# ALERT SERVICE BULLETIN

REPLACEMENT OF ROTARY BUCKLE

SERVICE BULLETIN NUMBER  
1150004-25-A01  
ISSUE 7

**Figure 2: Inspect the Cover for Looseness**

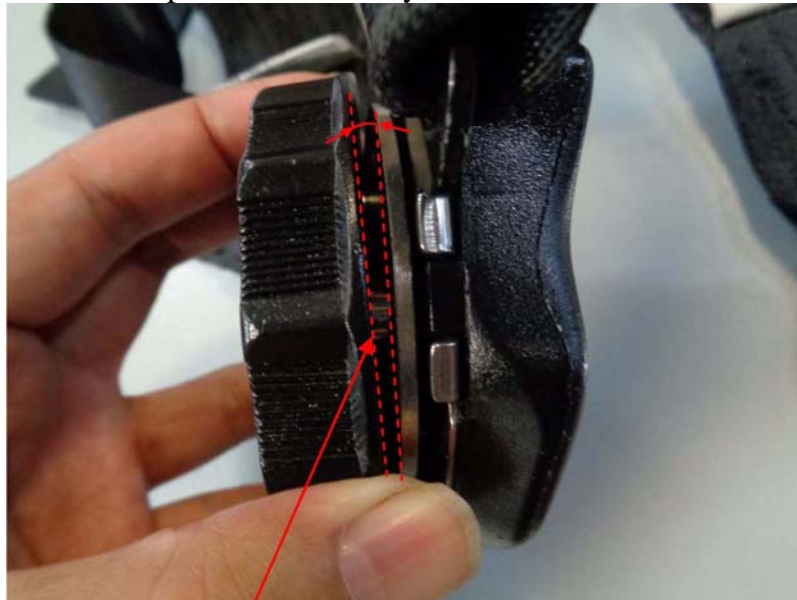
indicated in paragraph 1.A., (see Paragraph 2.A. for information on identifying the build date) then no further action is necessary. If the buckle build date is within the date range of this service bulletin, or if the build date is illegible or missing, check the buckle cover (front face that rotates to release the buckle). Viewing the buckle from the side, grasp the cover with one hand and attempt to rock the cover back and forth relative to the parallel plane of the buckle base (See Figure 2). If the cover is able to rock, so that there is a changing gap width between the buckle cover and buckle base, then the buckle must be replaced immediately.

If the above condition does not exist, the restraint can be returned to service, the buckle to be replaced within 180 days of the inspection, during a suitable maintenance interval, per §2 (Accomplishment Instruction). Buckles replaced under this service bulletin, whether due to manufacturing date within the build dates indicated or an illegible manufacturing date on the label shall be free of charge.
